XC18V00 PROM Errata and Deviations from XC18V00 Data Sheet

DS026-E01 (v1.1) March 10, 2004

Errata Notice

Figure 4: Recommended Resistor Value

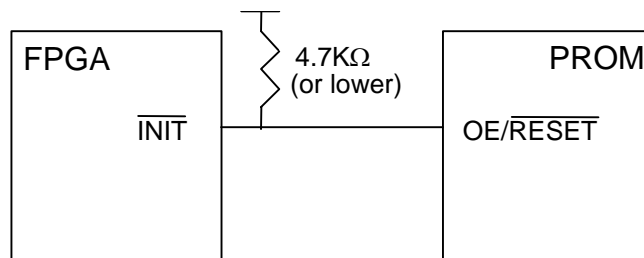
A pull-up resistor is required to properly propagate this signal through the PROM (Figure 1). Figure 2 shows a clean OE/RESET# (INIT#) signal. However, a slow ramp could potentially allow system noise to propagate through the PROM's input buffer (Figure 3), thus creating short reset pulses that might cause the internal circuits to get out of sync. The observed failure rate ranges from 1% to 5% of configuration cycles.

Follow the data sheet to ensure that an external 4.7KΩ (or lower) resistor is connected to the PROM's OE/RESET# pin and the FPGA's INIT pin. Ensure that the FPGA T_{ICCK} specification is met (500ns). This translates to a T_{RISE} and T_{FALL} time of 500 ns for the PROM's OE/RESET# signal.

Figure 8: (LED with Buffer Circuit)

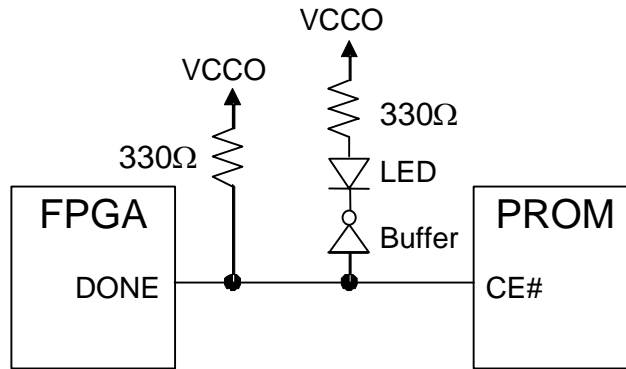
The FPGA has a sink current specification of 12 mA that is exceeded when an unbuffered LED is tied to the CE# (DONE) signal (Figure 5). In this scenario, the CE# (DONE) signal is held at an intermediate voltage level that mimics multiple input pulses (Figure 7). These pulses propagate through the PROM and cause the internal circuits to get out of sync. The observed failure rate is up to 50% of configuration cycles. Figure 6 shows a clean CE# (DONE) signal when it is not tied to an LED.

When using FPGA DONE to drive PROM CE# (to reduce standby power), make sure that the signal is within the specification and has a fast rise and fall time. Use an external buffer to drive any LED (Figure 8). If DONE is not used to drive CE#, it can be connected to an LED (Figure 9).

Figure 10: Asynchronous System

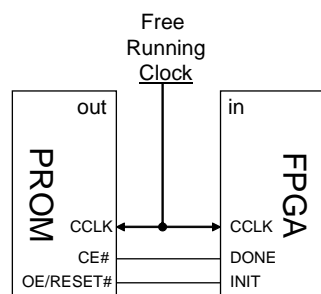
In most applications, the FPGA sources the CCLK signal, which synchronizes with the CE# (DONE) and OE/RESET# (INIT#) signals. However, in an asynchronous system (Figure 10), meaning when an external free-running clock drives the configuration clock signal (CCLK), there is a possibility that a missed or extra pulse (or pulses) can be interpreted by the PROM's internal counters as CCLK transitions while the OE/RESET# (INIT#) signal is in its intermediate phase (Figure 11). The observed failure rate ranges from 0.1% to 1% of configuration cycles.

There is no application work-around that will avoid exposure to the phenomenon when a free running clock is used. Therefore, customers who are using an external free-running clock need to convert their ordering code to SCD0799; this will ensure that they will not receive affected devices identified in Table 1, Table 2, and Table 3.

Figure 12: Counter Circuits

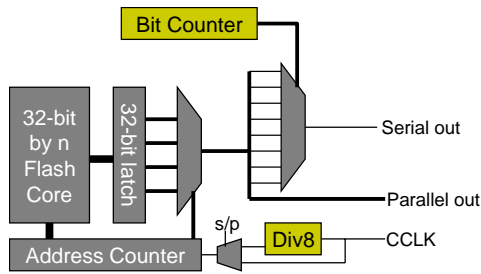
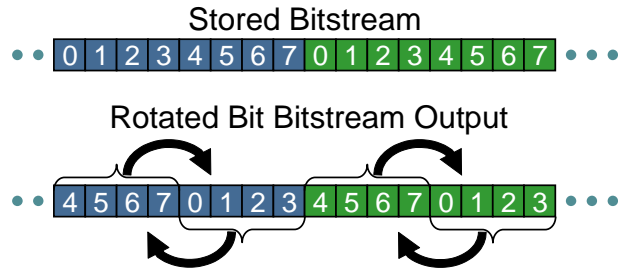
A Rotated Bit Pattern occurs when the Bit Counter and the Div8 circuit (Figure 12) becomes desynchronized. Data bits within a byte will be consistently rotated, byte by byte (Figure 13). Table 4 (above) summarizes the conditions where a Rotate Bit Pattern can occur.

Figure 14: Counter Circuits

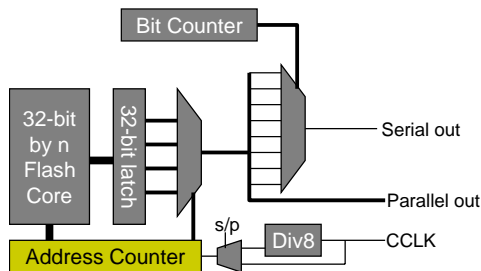
The Address Counter misses the first increment and repeats the first 32 bits. Table 4 (above) summarizes the conditions where an Extra 32 Bits pattern can occur.

Figure 16: Counter Circuits

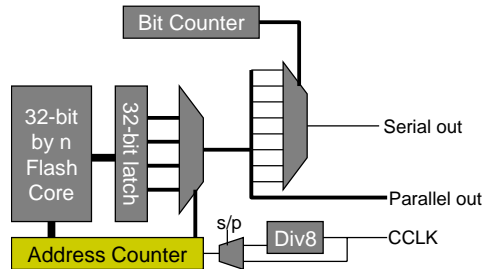
The Address Counter increments more than once and misses the second 32 bits. Table 4 (above) summarizes the conditions where a Missing 32 Bits pattern can occur.
